Appendix A Design Update 01, February 2025

Design Update Request/Notification

FORM A – SUMMARY OF REQUEST/NOTIFICATION			
Project:	The Medworth Energy from Waste Combined Heat and Power Facility Order 2024 Made: 20 February 2024		
Reference:	CP3_R2_DU01		
Originator:	Medworth CHP Limited (the Developer)		
Name:	Tim Marks	Position:	Head of Planning
Issued to:	Cambridgeshire County Council	Date issued:	05/12/2024

EfW CHP Facility Design Update 01

Figure 3.7i
EfW CHP Facility Elevations

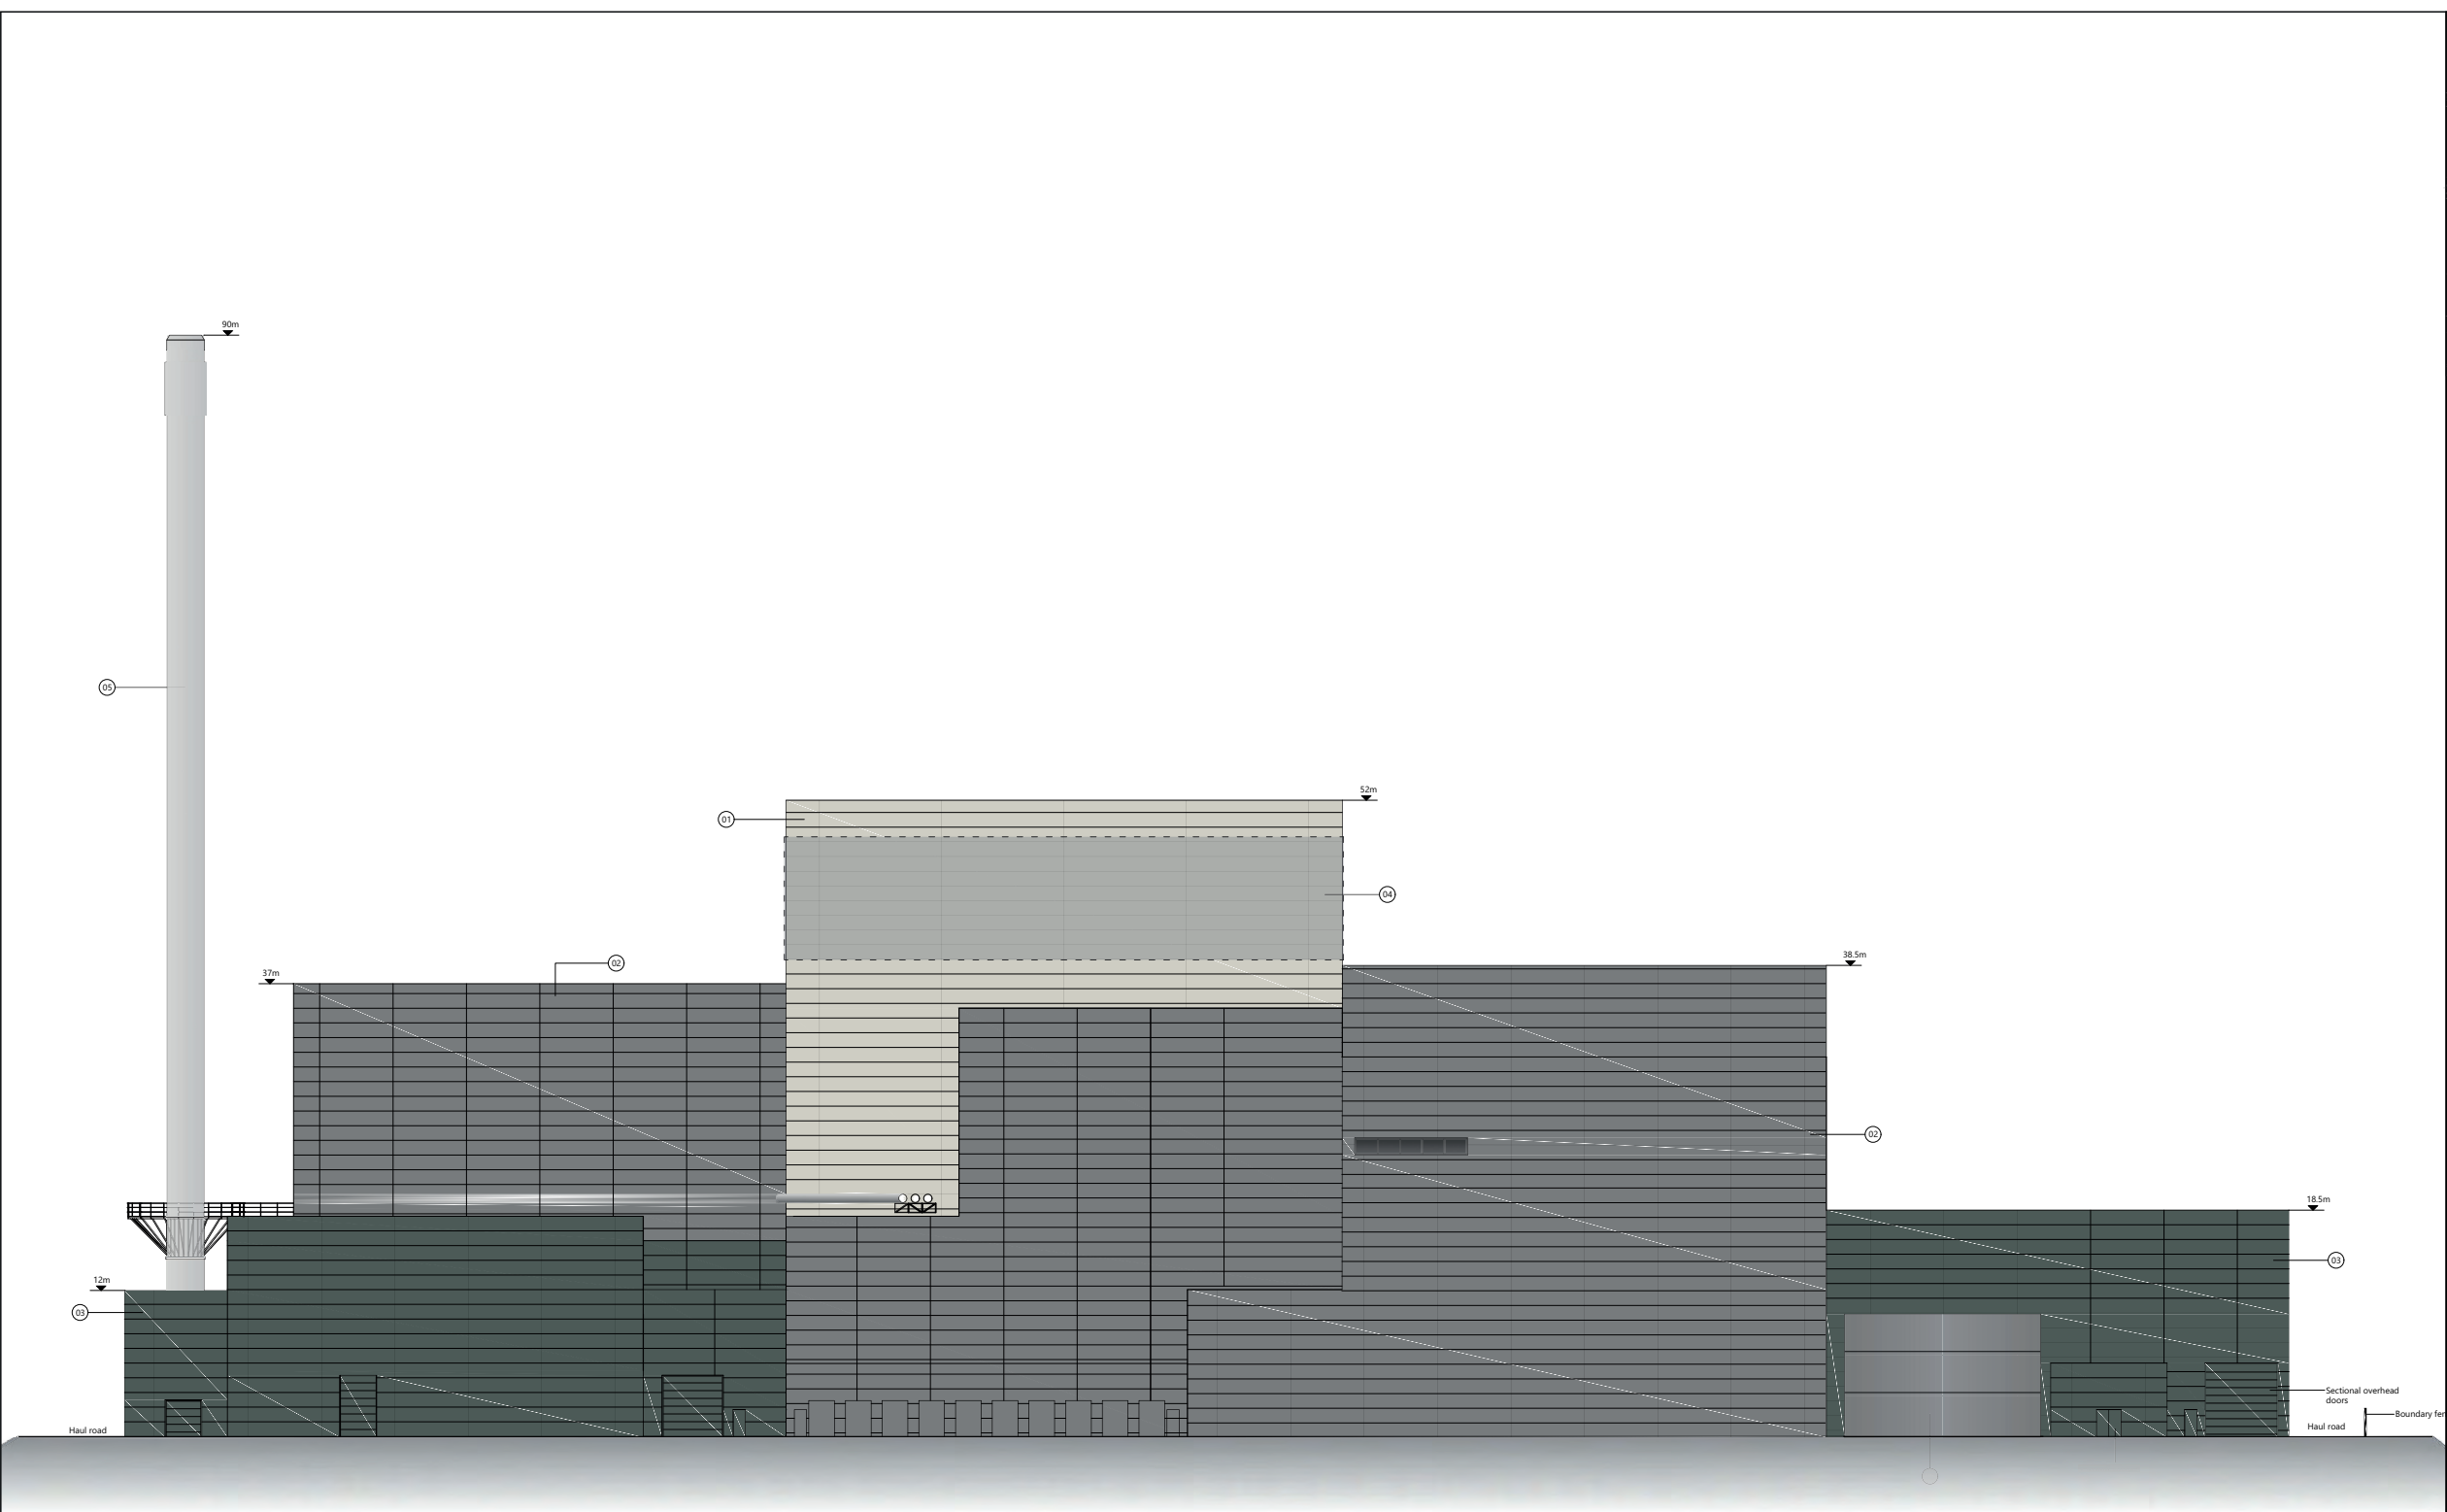
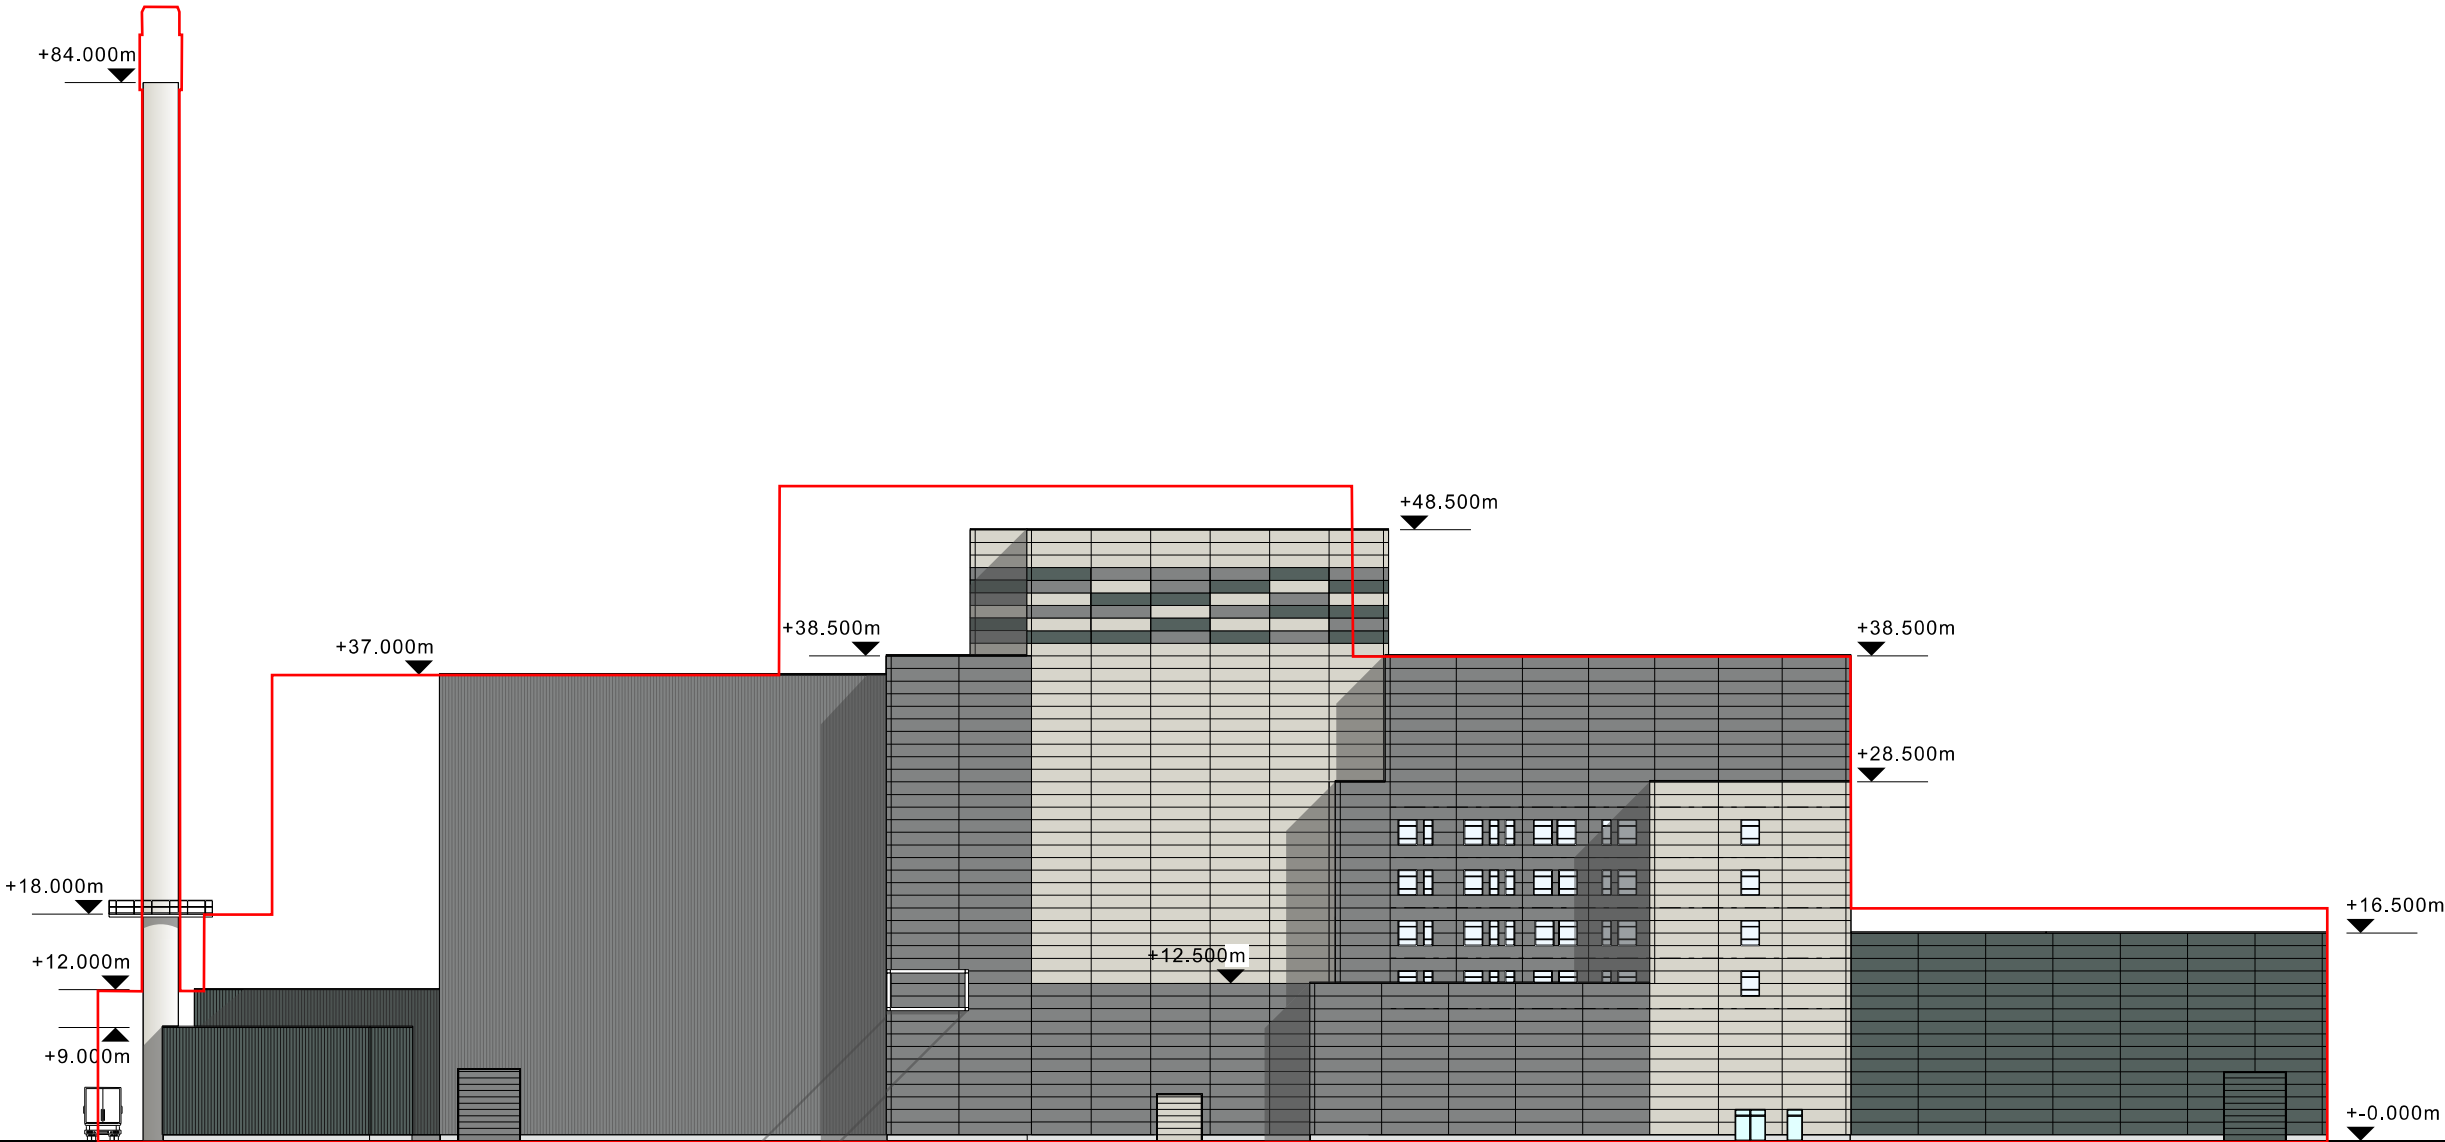
Outline taken from 3.7_i-iv-3.8-EfW-CHP-FacilityElevations (East Elevation)
